A PORTION OF SECTION 4, TOWNSHIP 14 SOUTH, RANGE 65 WEST OF THE 6TH P.M., EL PASO COUNTY, COLORADO

SITE DEVELOPMENT PLAN

#	Date	Issue / Description	
1	12/22/2017	2nd SUBMITTAL	
_			
_			
_			
_			
_			
			_
_			
_			_
_			
_

COVER SHEET

SITE PLAN

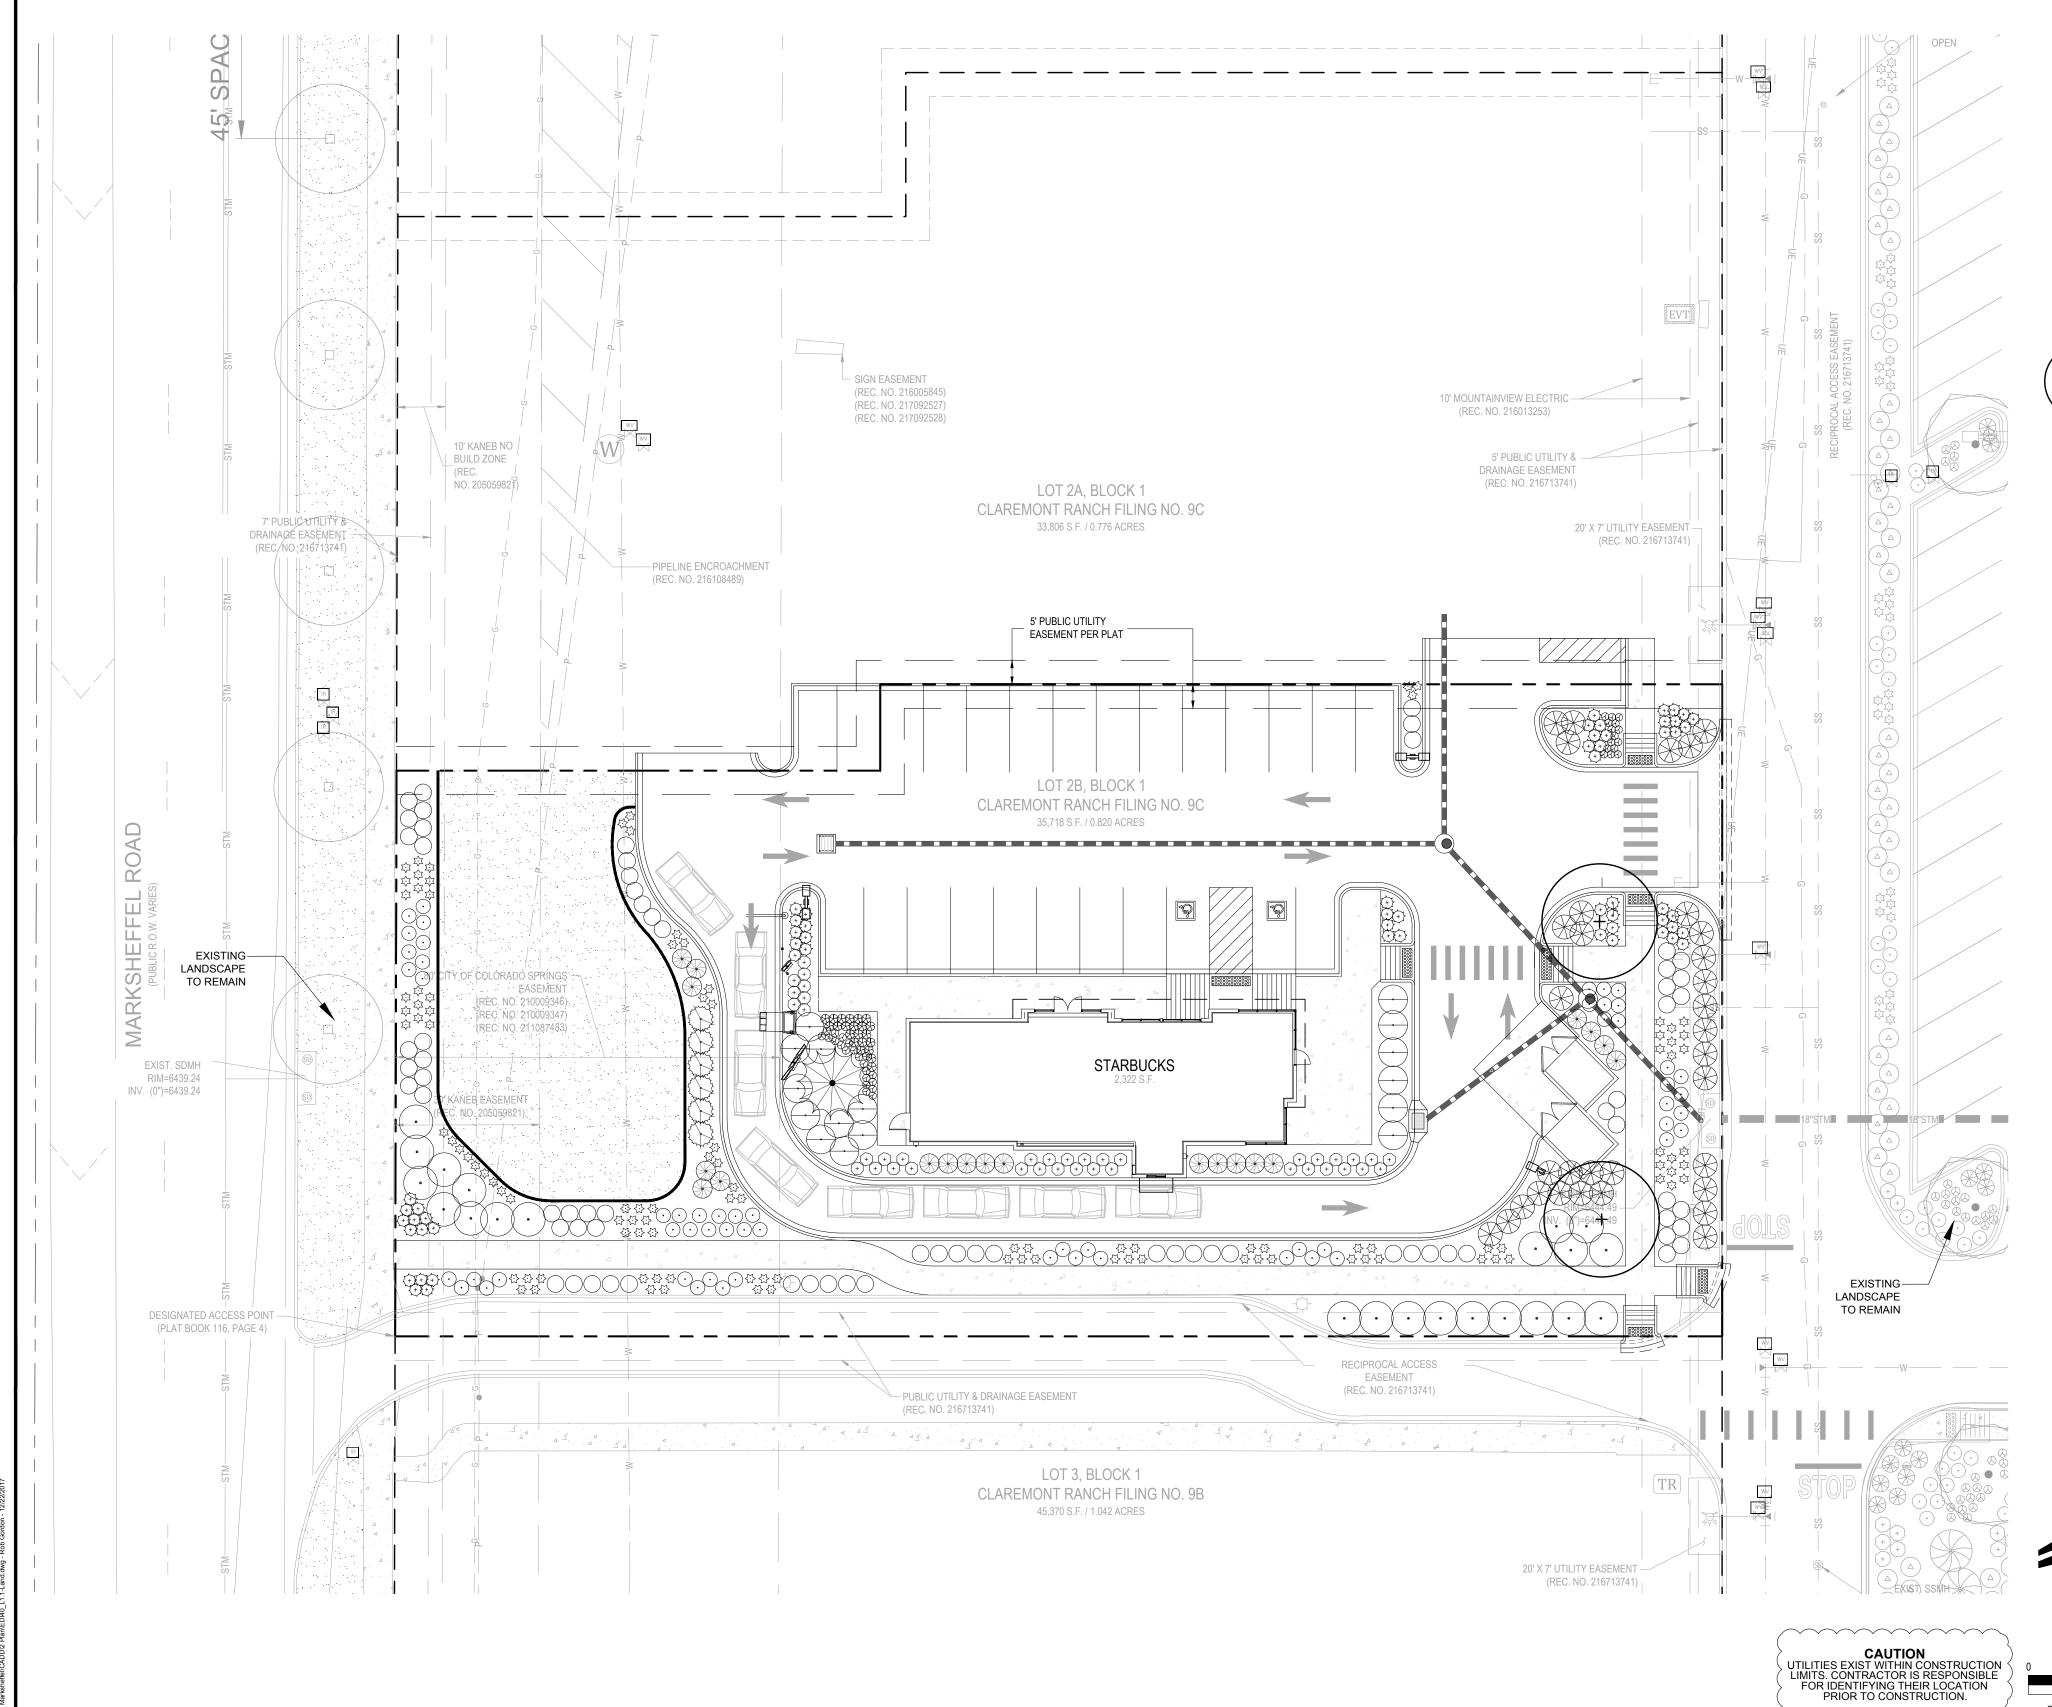
Add note for ADA:

The parties responsible for this plan have familiarized themselves with all current accessibility criteria and specifications and the proposed plan reflects all site elements required by the applicable ADA design standards and guidelines as published by the United States Department of Justice. Approval of this plan by El Paso County does not assure compliance with the ADA or any regulations or guidelines enacted or promulgated under or with respect to such laws.

LANDSCAPE PLAN

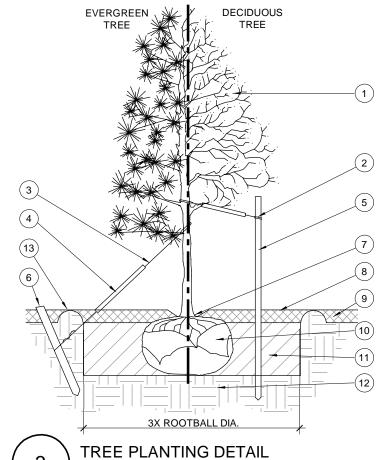
New county standards require an ADA note and route to be included on the Site Development Plan. The following is the correct template for the note:

"The parties responsible for this plan have familiarized themselves with all current accessibility criteria and specifications and the proposed plan reflects all site elements required by the applicable ADA design standards and guidelines as published by the United States Department of Justice. Approval of this plan by El Paso County does not assure compliance with the ADA or any regulations or guidelines enacted or promulgated under or with respect to such laws."

Each site development plan or non-residential site plan submitted to El Paso County shall clearly illustrate and identify the provision of ADA accessible exterior routes in accordance with the applicable ADA design standards and guidelines as published by the United States Department of Justice
